SERVICE BULLETIN

This is a revised and up to date index of section 8 service bulletins. Please file in the beginning of section 8 of your service manual for easy reference to applicable bulletins. Also enclosed are additional index sheets to keep the index up to date. This index will become effective March 1, 1984.

INDEX OF SERVICE BULLETINS

8-009

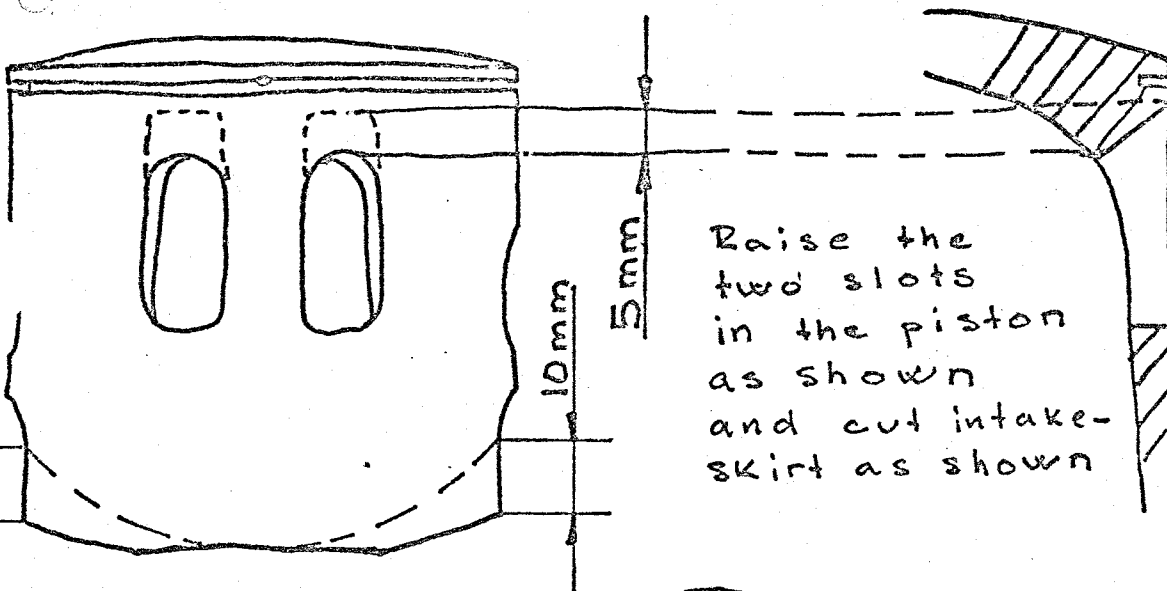
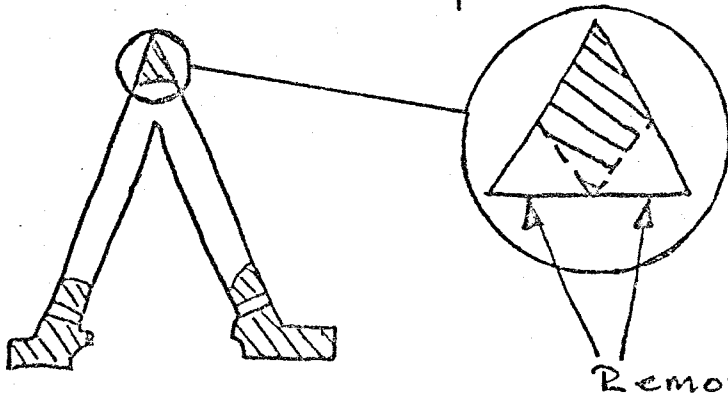
lower the intake ports 2mm each and widen the two boost ports 10mm each. It is very important that the angle at top of the ports remain the same when widening.

Raise the two slots in the piston as shown and cut intake-skirt as shown

modify the reed valve cone as shown.

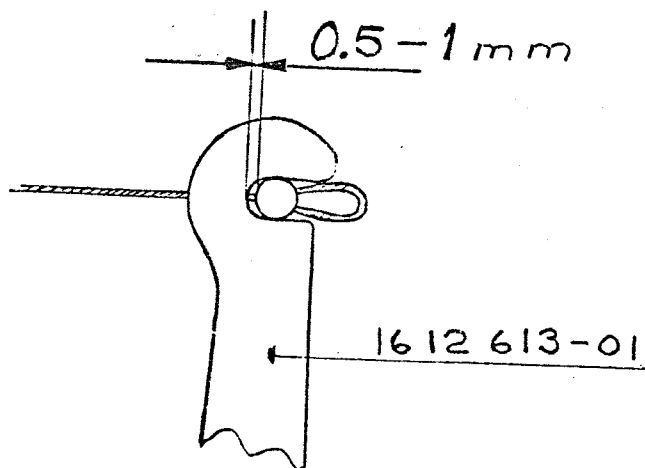
Please adjust engagement lever as shown. If the play between lever 16 12 613-01 and the cable nipple is excessive the engine will not disengage properly.

8-059

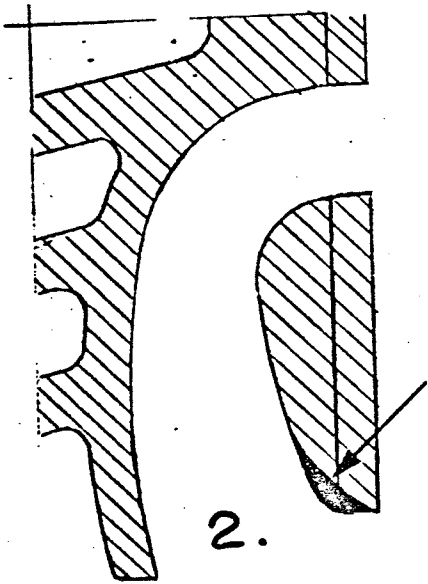
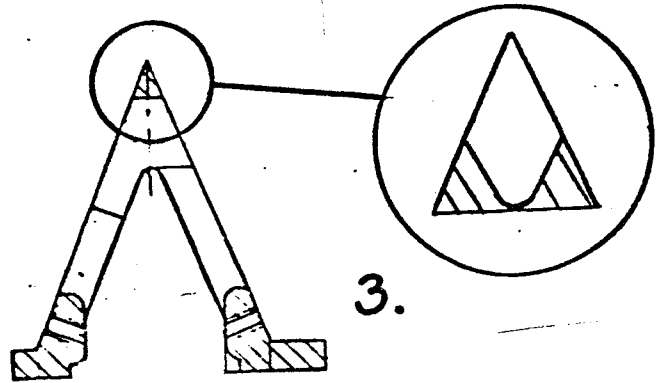
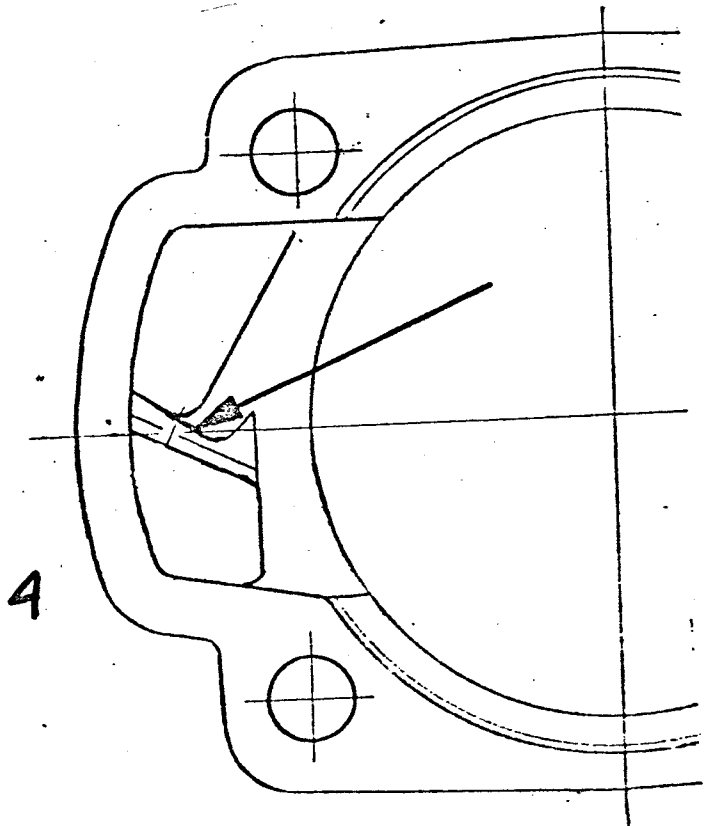
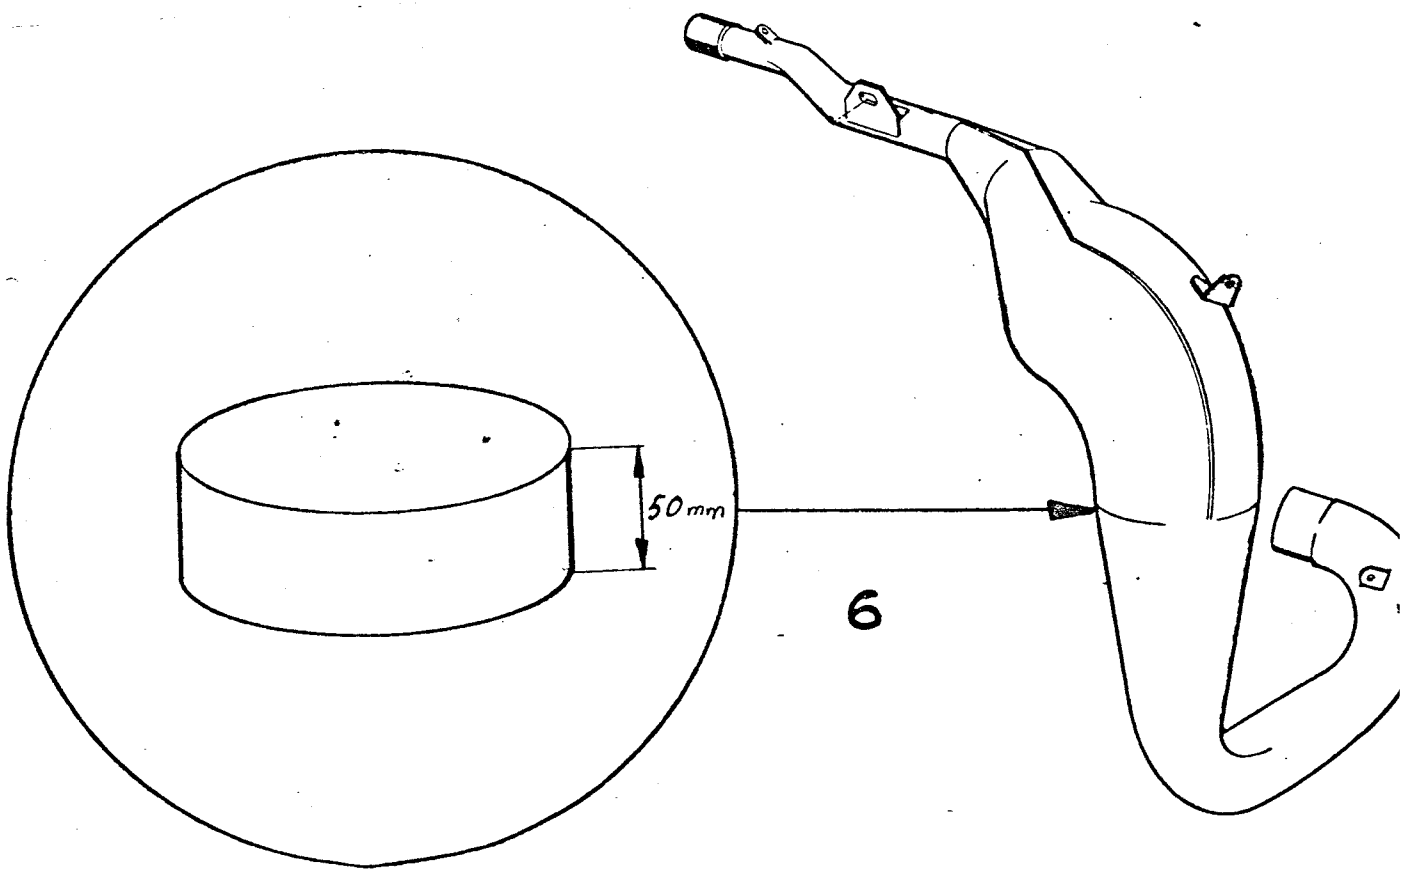
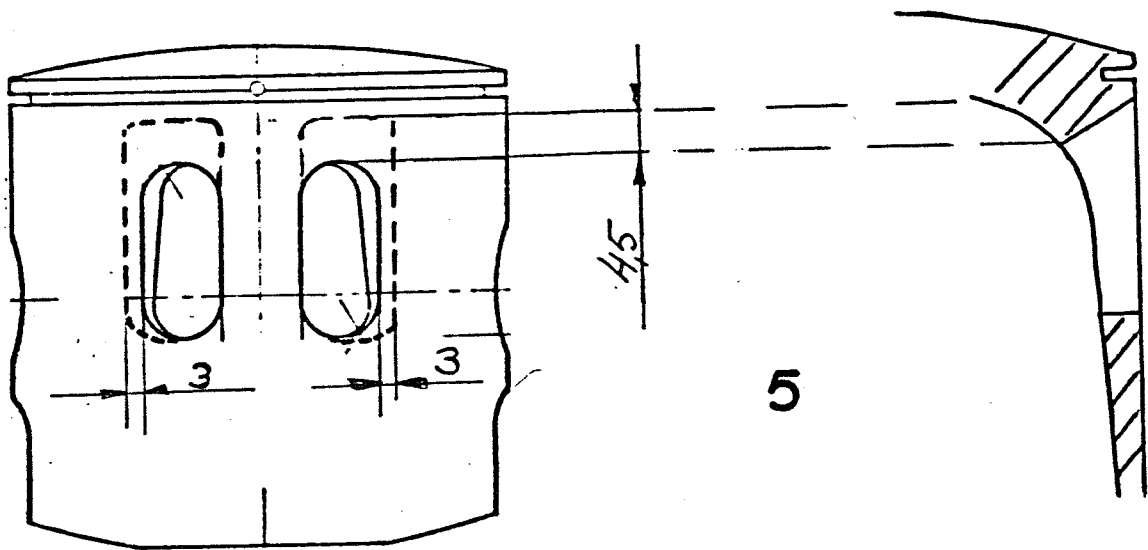
- Fig 1: Modify exhaustport as shown, make sure that no metal is removed in the upper corners of the port.
- Fig 2: Remove some metal and smooth the entrance of the transferport, where the arrow points.
- Fig 3: Modify the front piece of the reedvalve holder (16-10-357-01) as enlargement shows.
- Fig 4: Sharpen the dividing wall between the main and auxiliary transferport.
- Fig 5: Raise and widen the two piston slots as the left figure shows. Figure at right shows the approximate upper angle of a slot when modified.
- Fig 6: Add 50mm (2.0 inches) to the exhaust pipe as figure shows. NOTE: This only applies when the exhaust pipe has not been modified by the factory.

8-077

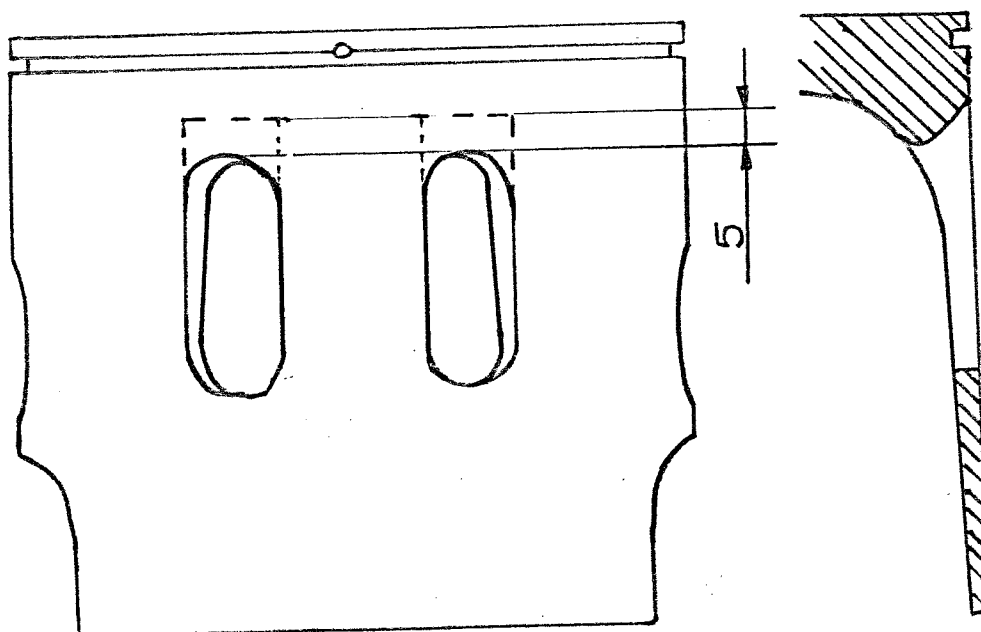
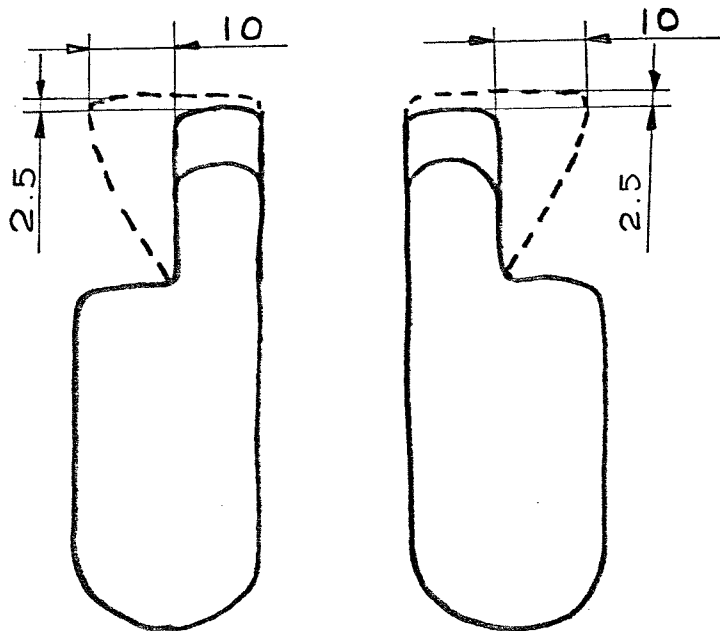
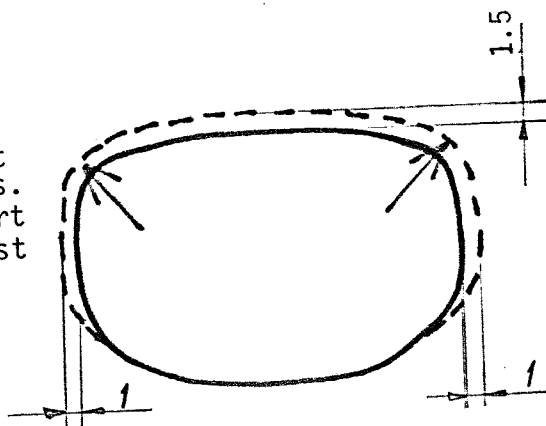
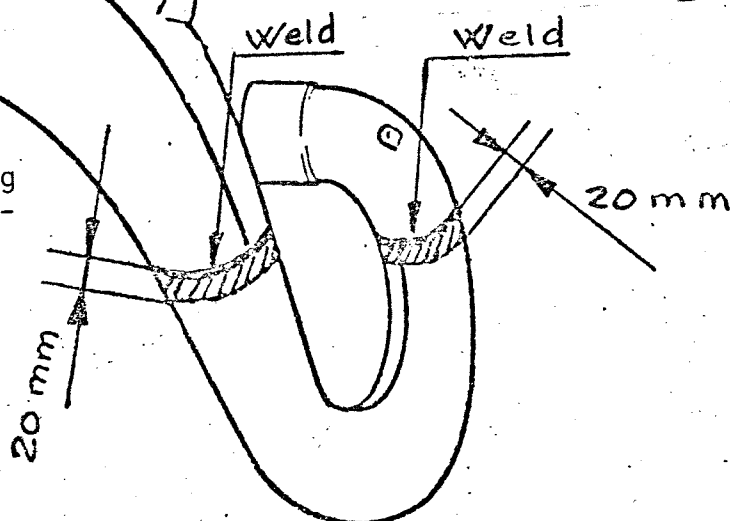
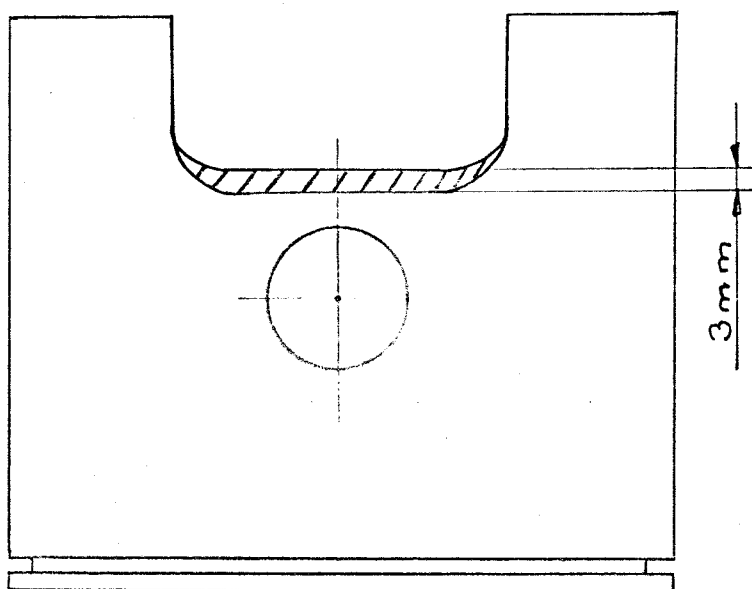
Widen the two boost ports 10mm as shown, also raise them to the same height as the two transfer ports (about 2.5mm). It is important that the boost port angle remains the same.

Widen the piston slots 1.5mm each and raise them 5mm, as the left figure shows. The figure on the right shows a cut through one of the piston slots and the approximate angle of the port when raised.

Raise the exhaust port 1.5mm and widen it 1mm on each side as the dotted line shows. Be careful with the upper edge on the port especially where the arrows show. It must be a smooth radius between the top edge and the side edges.

Shorten the exhaust pipe, by cutting 20mm (3/4 in.) off, below the existing welds as figure shows. Thereby shortening the pipe a total of 40 mm.

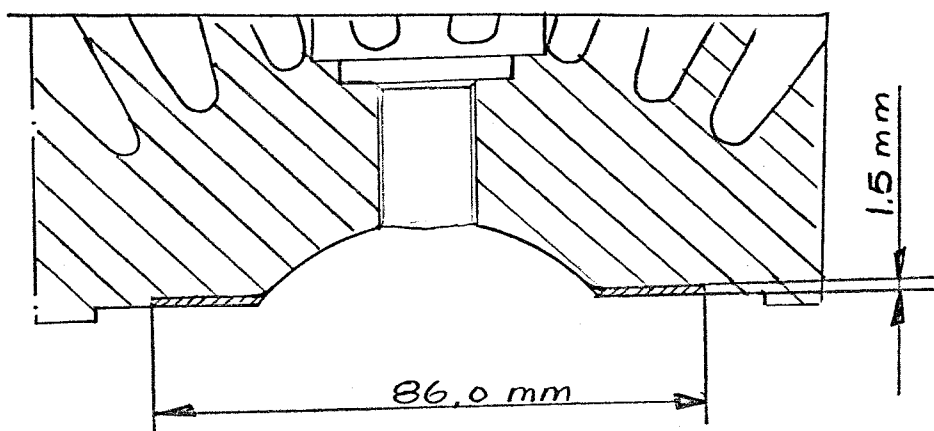
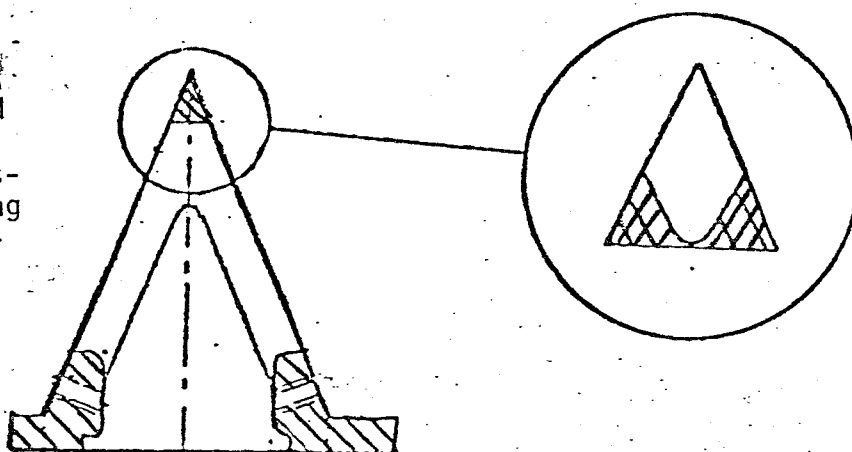
This figure shows a cut straight through the center of the cylinder head showing the combustion chamber. With an increase of cylinder volume it is also necessary to increase the volume of the combustion chamber in order to maintain the same compression ratio as before. Therefore raise the squishband 1.5mm on a 86mm diameter (the sealing surface between the cylinder and head is not touched).

Sharpen the front piece of the reed valve holders (1610 357-01) Remove all the (in the enlargement), cross-marked material. When re-assembling the reedvalves, make sure the sealing surface is minimum 1mm all around the reedvalve holder.

8-079

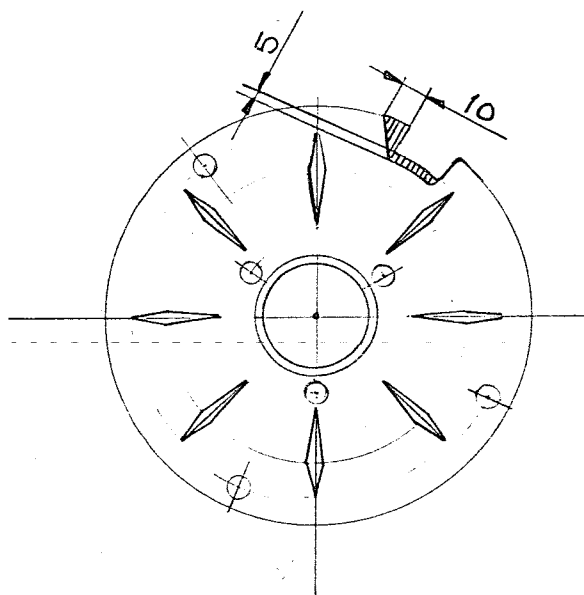
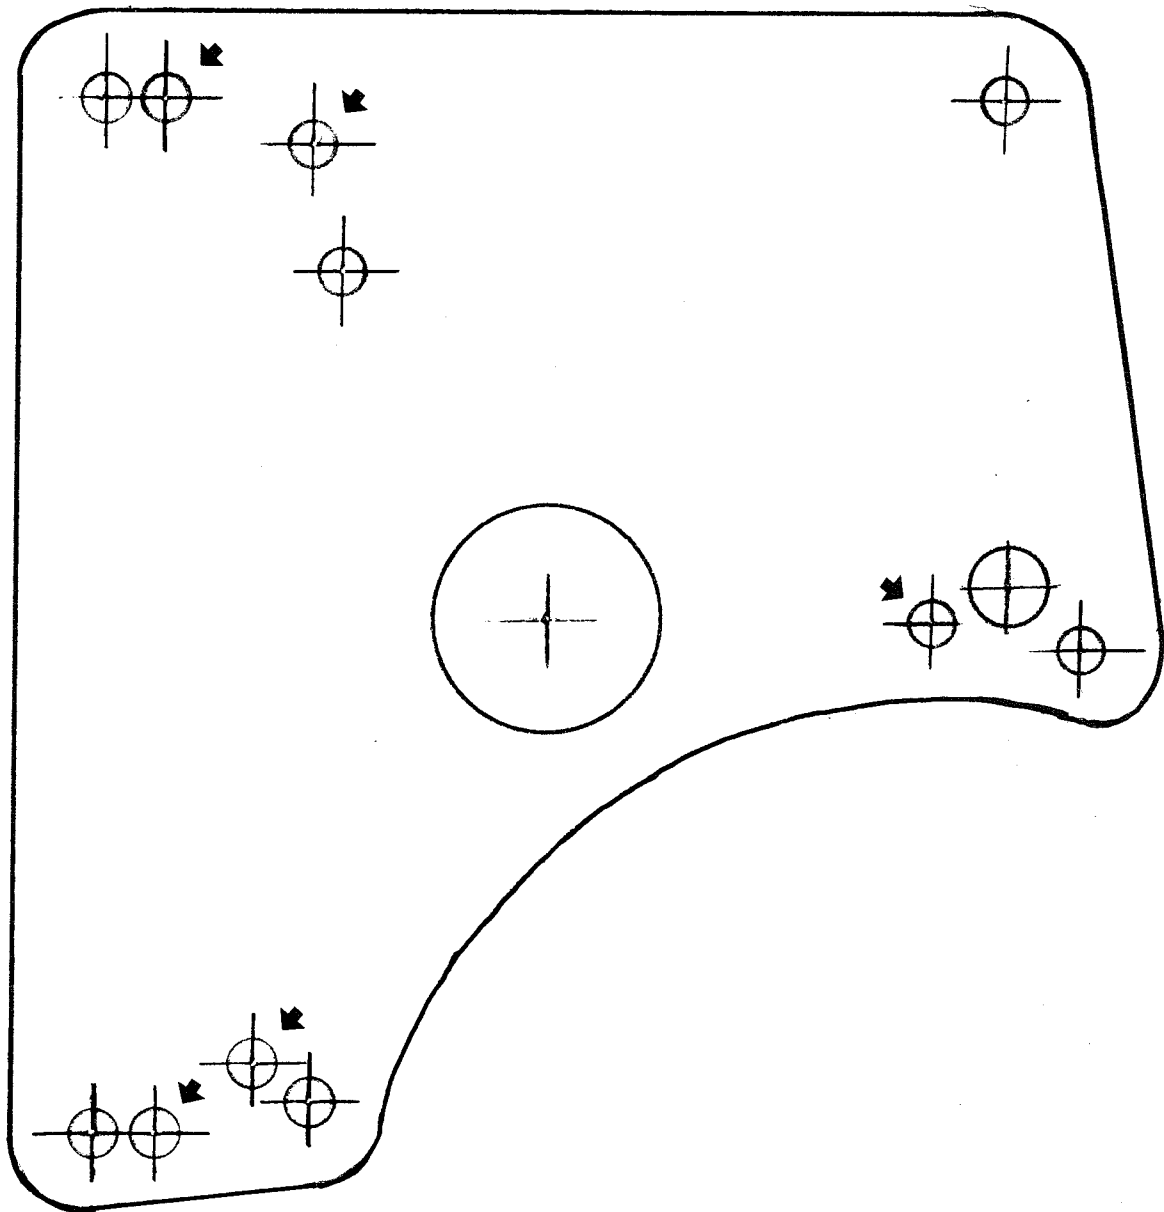
There is a sharp bend in the wires coming from the ignition stator. To eliminate the risk of the wires being exposed at the bend, an increase in width and depth of the backing plate cutaway can be made.

After removing the ignition rotor and stator the backing plate can now be removed. The stator backing plate can be modified as shown in the following figure diagram. This can be easily done with a round file. When reassembling, re-torque the flywheel nut to no more than 50 ft., lbs.

Fig. on right shows
ignition backing plate.
Modify as shown
(Measurements in mm.)

RE: 1981 430 CR, XC, WR - PISTON TOUCHING HEAD

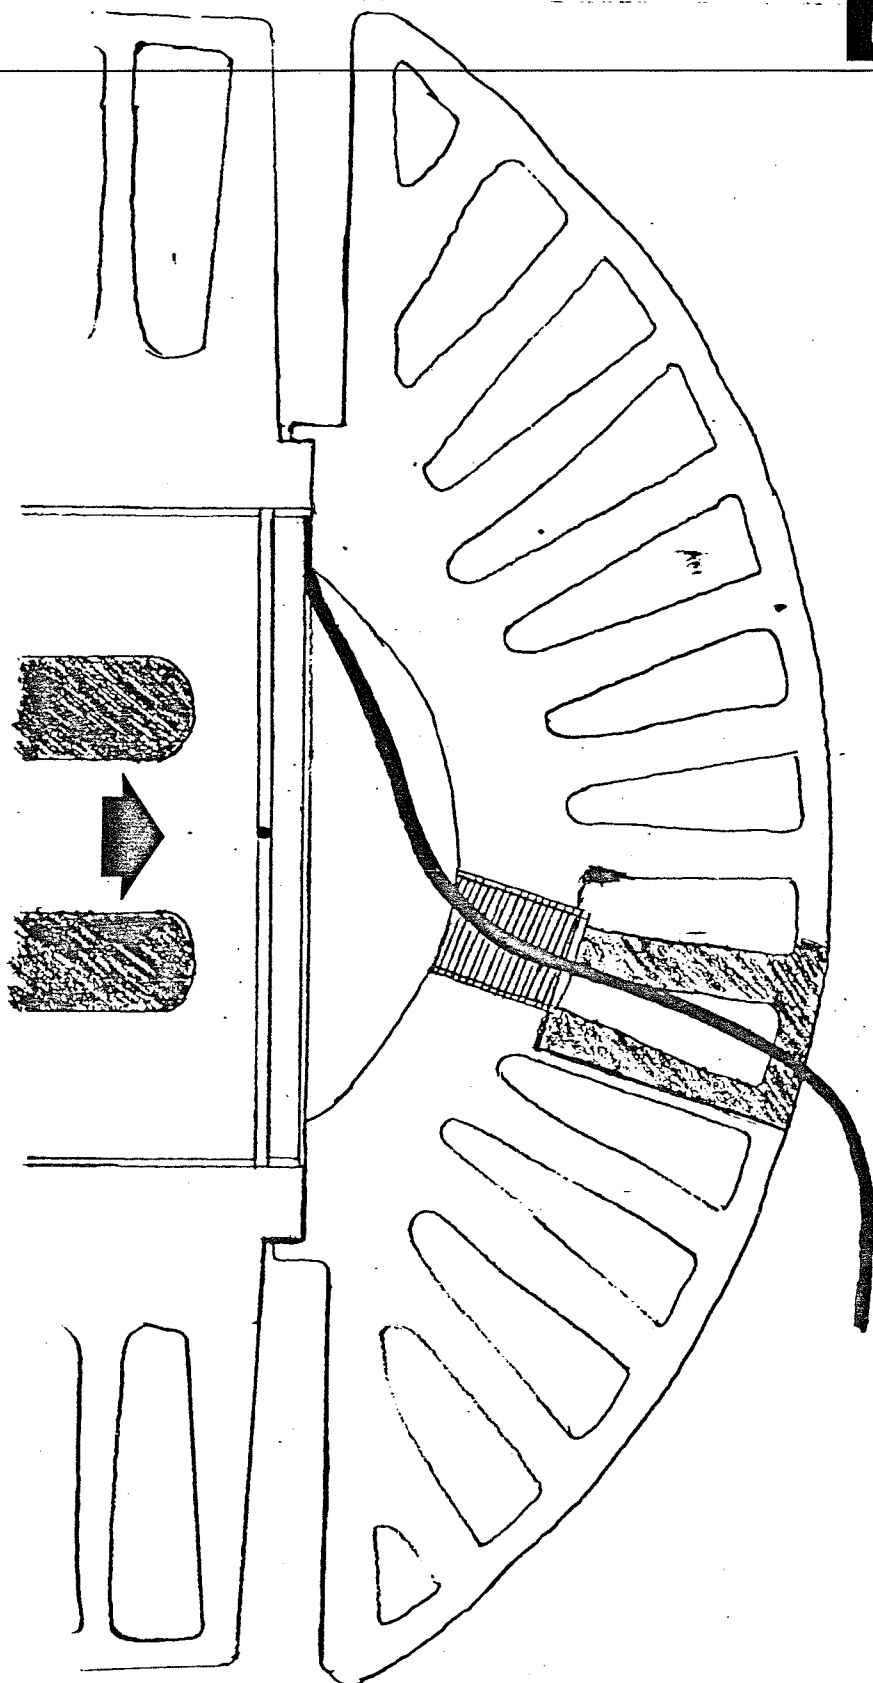
It is possible for 430 engines within the above listed engine numbers to have too small of a clearance between the cylinder head and piston at top dead center. If this is the case, the piston will show signs of touching the head possibly even causing the ring to stick in its groove.

Measure the amount of clearance by inserting some solder into the spark plug hole and bringing the piston to top dead center. (see drawing) If the measured clearance is less than 1.0 mm it will be necessary to have the head machined. Machine the cylinder head in a lathe, removing metal only at the point where the piston could contact the head. Remove enough metal so that a minimum of 1.0 mm is reached between the cylinder head and piston at top dead center.
